Shollenberger Amphitheater Project Update

RECREATION, MUSIC AND PARKS COMMISSION

JUNE 19, 2024

Southwest vs South Alignment

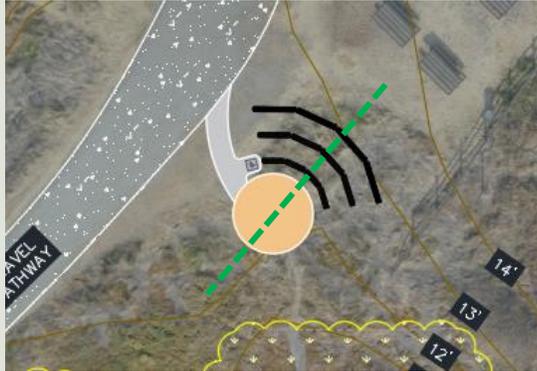
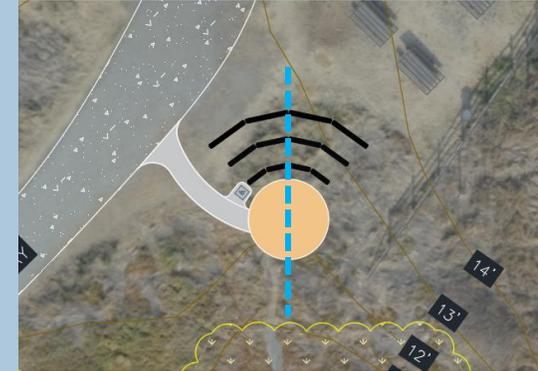
❑ **Amphitheater orientation to face more south**

- Alternative orientation to be shown during this presentation.

Option A – Southwest
(parallel with existing fence and road)

Option B - South

Current Design Overview

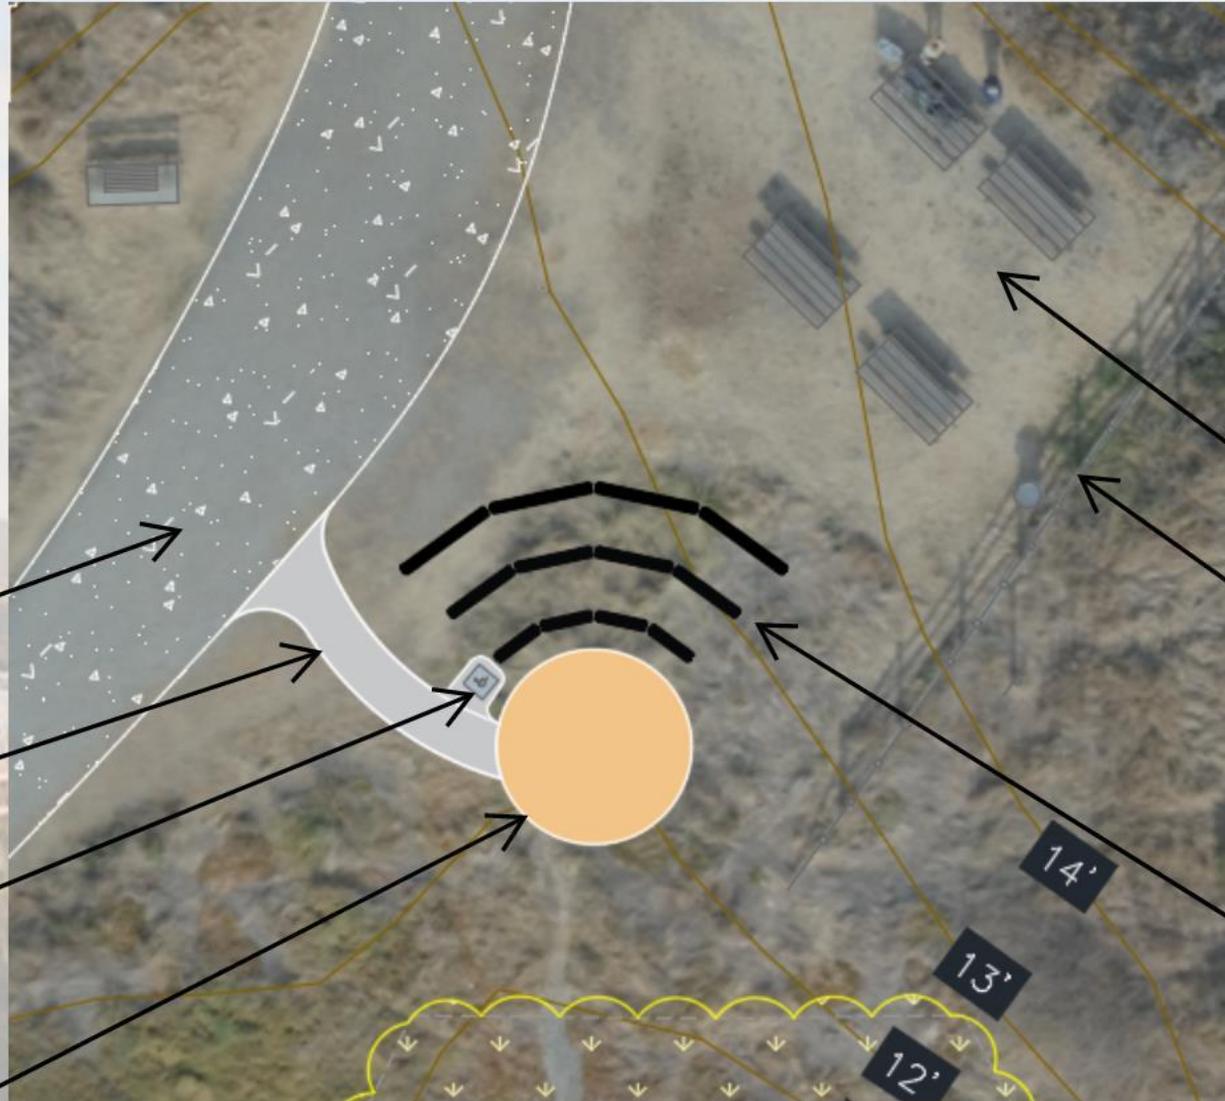
❑ **Downsize the number of seats**

❑ **Informal meeting area**

❑ **No elevated concrete stage**

Work on adjacent gravel roadway to facilitate wheelchair access to proposed stage pathway

ADA compliant pathway from existing road to top of stage.

Level landing for wheelchair users.

- 15ft-diameter circular stage.
- Low Carbon Concrete on grade level.
- Stamped and Colored finish.
- Possibility to add custom stamp with art at the center of the stage.

Proposed arc arrangement for benches.

Row close together to limit footprint of amphitheater.

Tiered seatings for improved visibility and aesthetics
